Doreen Garments Ltd

50-60, Dakkhin Panishail, NK Link Road, Kashimpur, Gazipur, Dhaka
(23.987086, 90.260215)
2nd April 2014

Observations

Main Building: High Column Loads

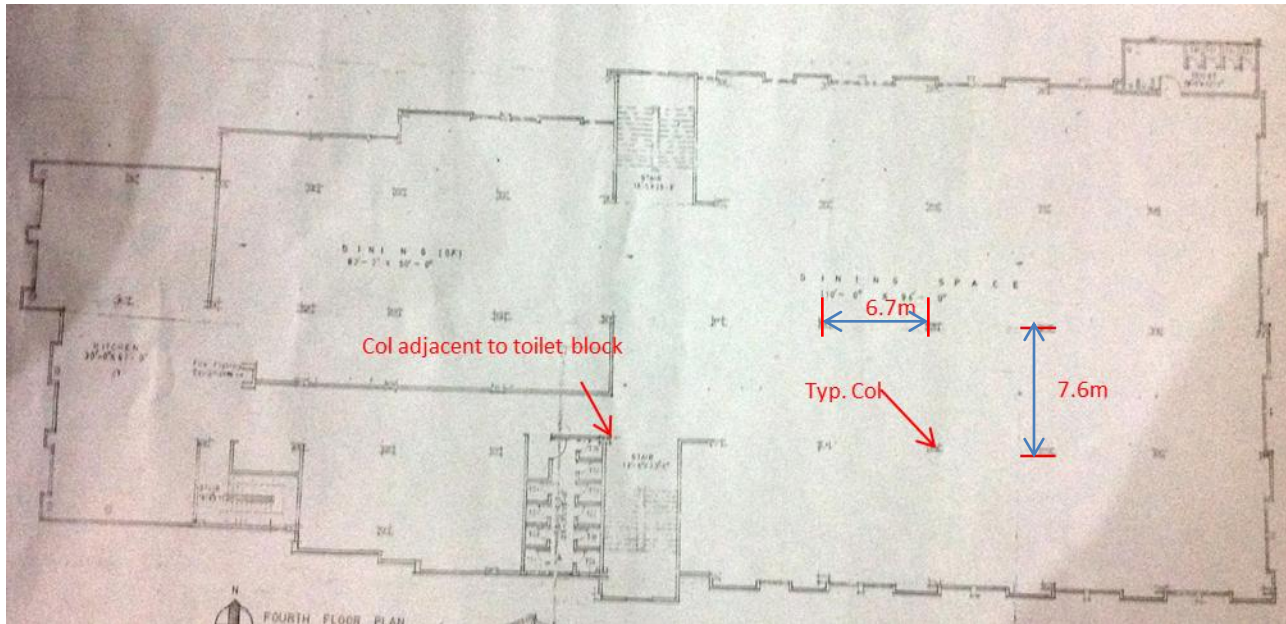
Main Building: High Column Loads- Detailed Engineering Assessment Required

Preliminary calculations indicate that column working stress is at a high level in the main building. For columns adjacent to toilet areas, considerable loading was observed arising from numerous masonry partitions, plinths and reinforced concrete slab ceilings.

A Detailed Engineering Assessment of the building is required (see attached scope). The engineer is to perform detailed calculations based on the 'as constructed' structural arrangement, material properties and loading to verify column size suitability. If required, column loading shall be reduced, and columns possibly strengthened.
